APPLICATION NO.	FILING DATE	FIRST NAMED INVENTOR	ATTORNEY DOCKET NO.	CONFIRMATION NO.
10/567,121	02/03/2006	Kenta Hatano	1163-0543PUS1	3023
2292 7590 04/17/2009 BIRCH STEWART KOLASCH & BIRCH PO BOX 747 FALLS CHURCH, VA 22040-0747				
EXAMINER DESAL, NAISHADH N				
ART UNIT 2834		PAPER NUMBER		
NOTIFICATION DATE 04/17/2009		DELIVERY MODE ELECTRONIC

Office Action Summary

DETAILED ACTION

FIG.4A

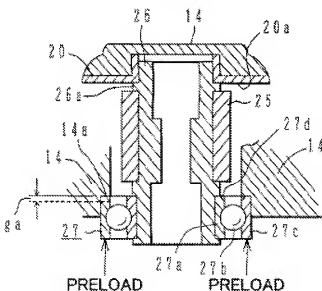
A motor-bearing holding structure comprising (Figs 4A&B):

a first bearing (Fig 4A,27) having an inner wheel (Fig 4A,27a) and an external wheel (Fig 4A,27c),

Watanabe et al does not explicitly teach that "the second end portion of the metallic member is rotatably held to the inner wheel at two or more places at equally spaced intervals around a rotary central axis of the molded rotor".

4. Regarding claim 7, Watanabe et al teaches a second bearing (Fig 4B,102,103) wherein the molded rotor (method of making, patentable weight not given) is rotatably and axially movable over a predefined range held by the first and second bearings (it is obvious that the washer (Fig 1,28) will allow movement of the bearings in the axial direction).

FIG.1

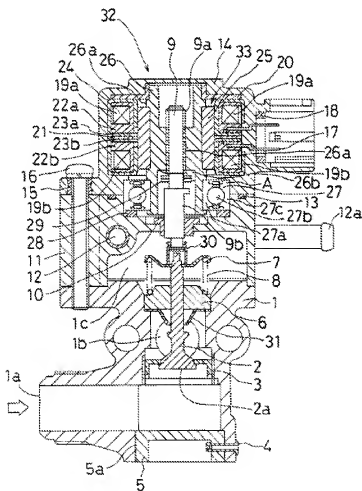
a metallic member (Fig 1,28) having a first end portion and a second end portion, wherein the first end portion (it is clear that element 28 in Fig 1 has a first and second end portion) is integrally molded with the rotor (method of making limitation, patentable weight not given); and

2. Regarding claim 3, Watanabe et al teaches (Fig 1,28) a washer that is fitted to the external wheel of the metallic member protruding from the rotor is secured to the metallic member under conditions where the washer is pressed against the bearing. Also Ohta et al (Fig 1,51) teaches the use of a plate spring which directly abuts the bearing.

7. Regarding claim 14, Watanabe et al teaches that the metallic member is a ring-shape metallic member (Fig 1,28).

FIG. 1

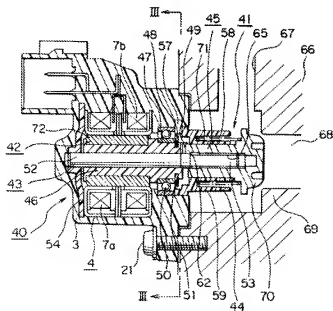
Ohta et al teaches a device having a metallic member (Fig 1,51 and Col 5 ll 55-56) wherein the second end portion of the metallic member (Fig 7,51) is rotatably held to the inner wheel (Fig 1 by element 47 indicating inner race / wheel of bearing) at two or more places at equally spaced intervals around a rotary central axis of the molded rotor (Figs 7 and 8 element 51).

6. Regarding claim 13, Ohta et al teaches that the external diameter of the washer (Figs 7 and 8,51) is superimposed on the inner wheel (Fig 1,51) so the washer can be pressed to be abutted against the inner wheel with a uniform force.

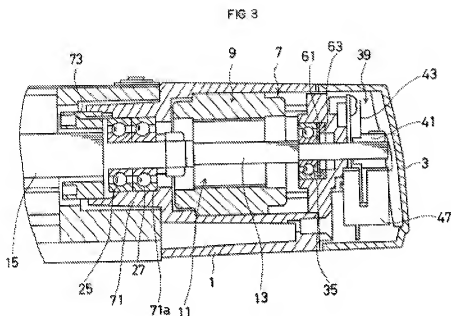
3. Regarding claim 4, Ohta et al teaches (Figs 7 and 8) that the molded part of the metallic member is provided with a concave portion.
